Planning Commission Staff Report

Project Type: Site Development Section Plan

Meeting Date: May 11th, 2015

Description: Chesterfield Blue Valley, Lot 1C (Cavender's Boot City): A Site Development

Chesterfield Blue Valley, Lot 10 LANDSCAPE PLAN

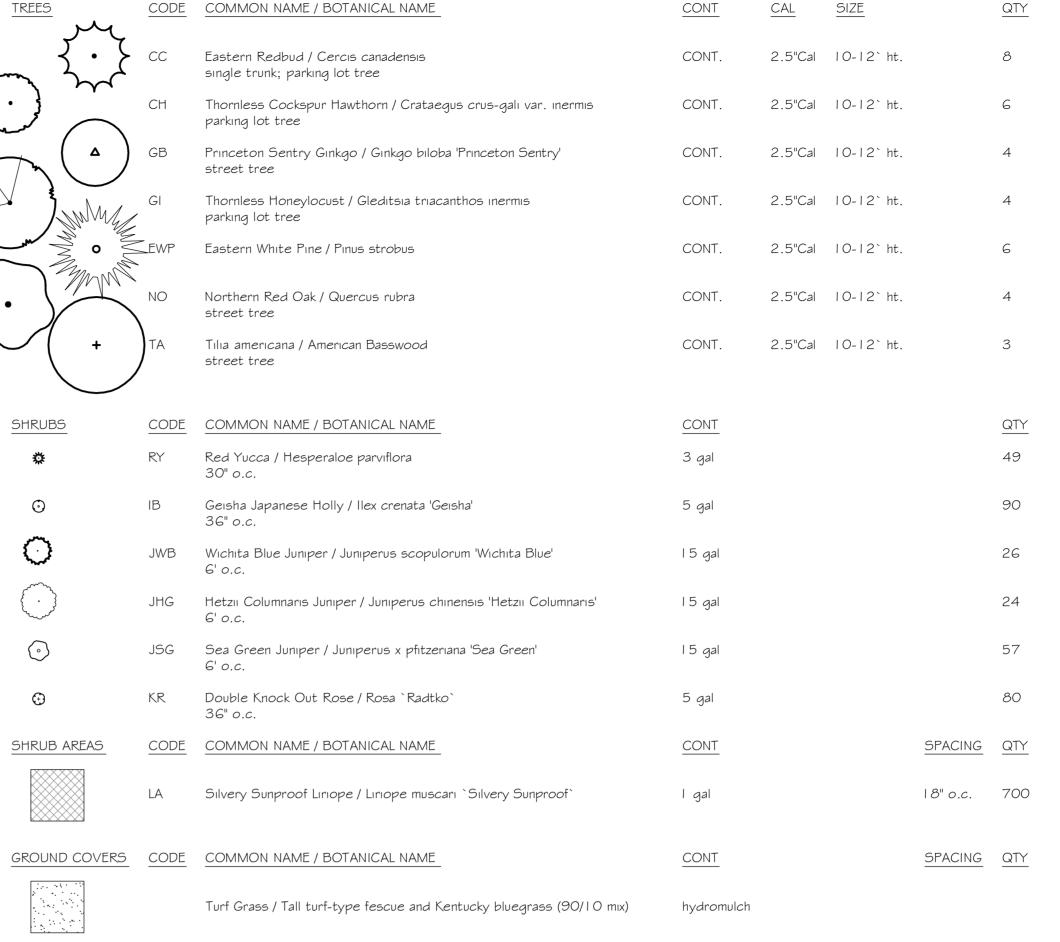
- 2. Add landscaping, especially evergreen trees, on the north side of the fire-lane on the rear of the building to provide screening for the loading areas.

- 3. Add landscaping to break up the large paved areas between the building and parking areas and consider adding flowering trees on the side elevations, near the doors.

- The Landscape Plan has been updated to include 24 evergreen trees/shrubs, Hetzii Columnaris Juniper (JHG), on the north side of the fire-lane. These trees range from 10 to 15 feet in height and have a 3 to 5 foot spread, providing screening for the loading spaces located at the rear of the building.

- The applicant has increased the planting areas on both sides of the buildings and landscaped the entire rear side of the building, in turn reducing the paved areas around the building. The Landscape Plan depicts Geisha Japanese Hollies and Double Knock-Out Roses on both sides of the building. Staff, including the City Arborist, has reviewed this selection and finds them to be appropriate for the proposed locations. It is Staff's opinion that trees in this location would not thrive, due to the proximity to the building and size of the landscape beds.

Perspectives

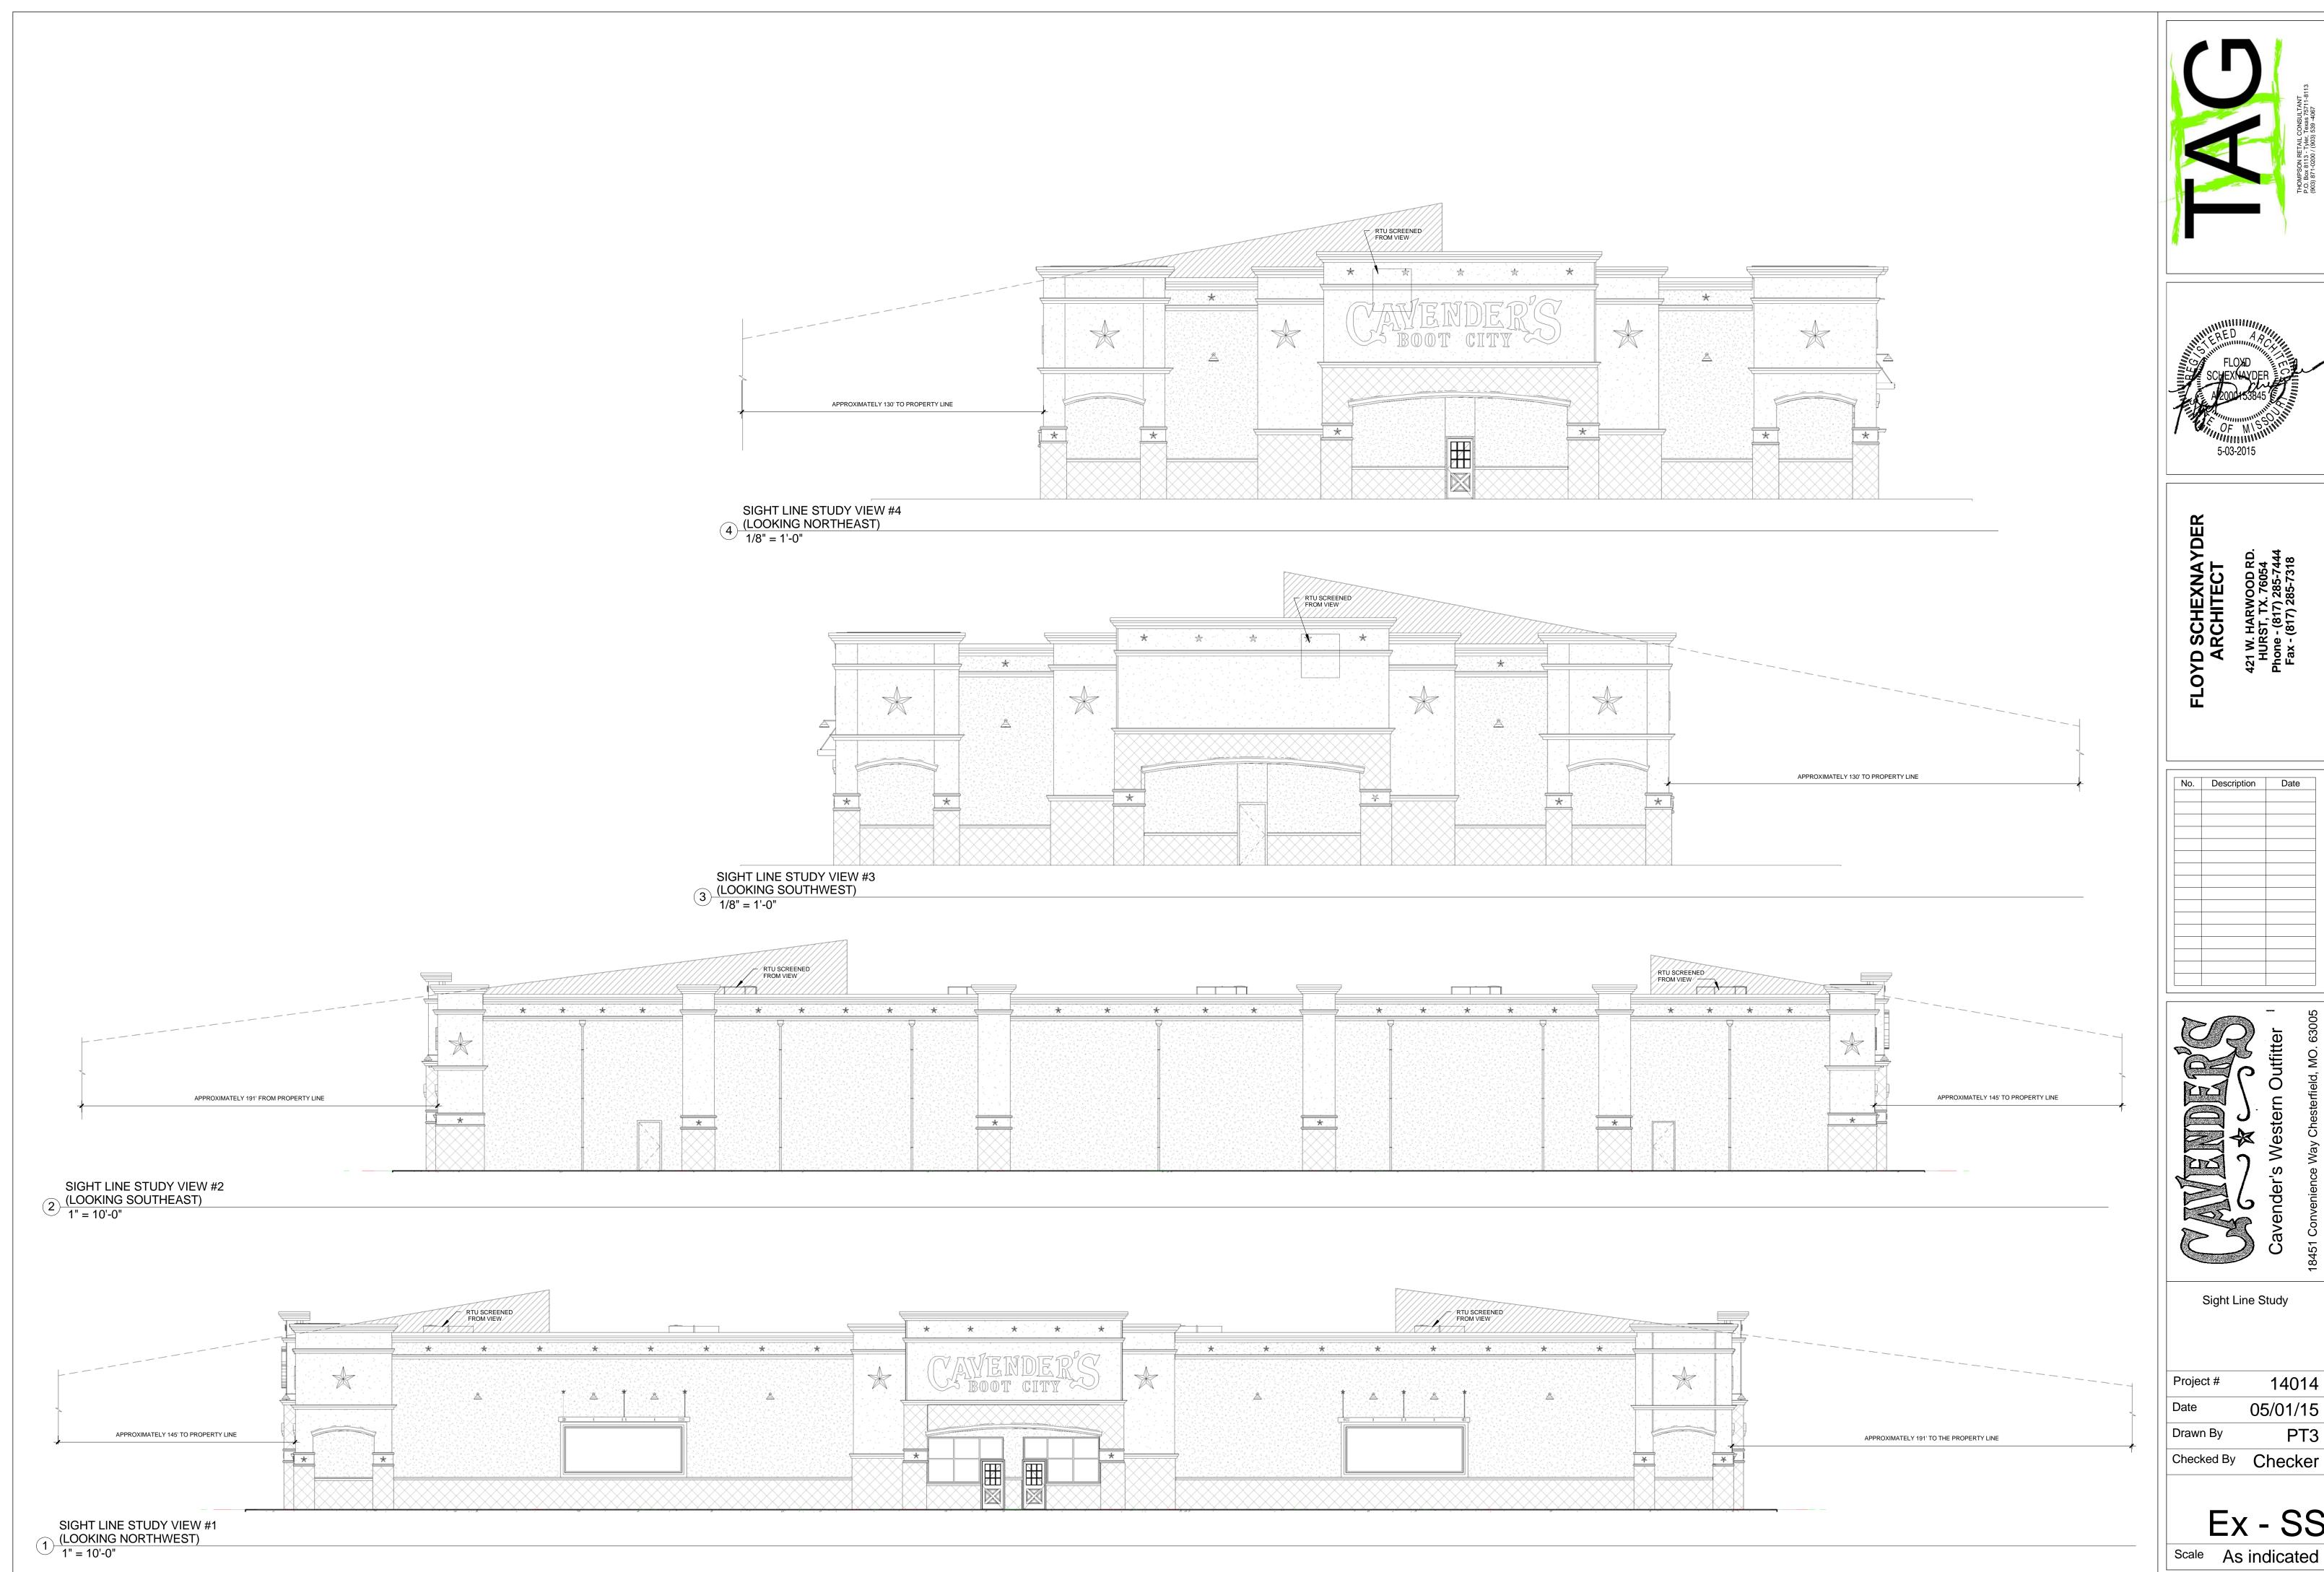
1. Break-up the rear elevation by adding the stone wainscoting on the rear façade, similar to the other three (3) façades of the building and/or include additional landscaping along the rear elevation.

In response to this recommendation, the applicant has provided a continuous row of evergreen shrubs along the rear elevation. The applicant has proposed 26 Wichita Blue Junipers (JWB) along the rear elevation; these shrubs range from 10 to 15 feet in height with a spread ranging from 4 to 6 feet. In addition, approximately 21 Geisha Japanese Hollies are proposed; these range from 3 to 4 feet in height and spread. These plantings will provide both vertical and horizontal interest along the rear elevation. The applicant has not proposed additional wainscoting on this elevation as it will not be visible through the planting.

Fixture "C" Cavender's Wester Outffiter - Chesterfield, MO

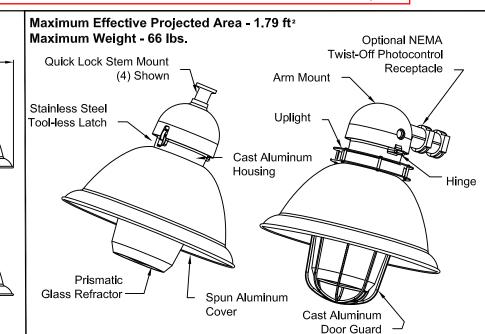
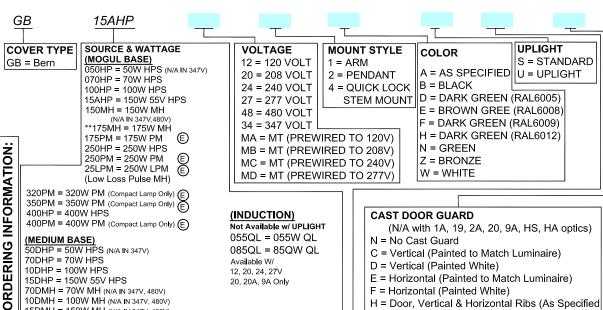
- 4. Provide additional lighting information on the decorative, lighted stars to ensure there will be no light-trespass. Provide night-time exhibits of these lighting stars.

- Examples of this fixture were provided by the applicant. These examples are shown and discussed on Page 5 of this report. Staff has no concerns regarding this fixture and the amount of light emitted from it.
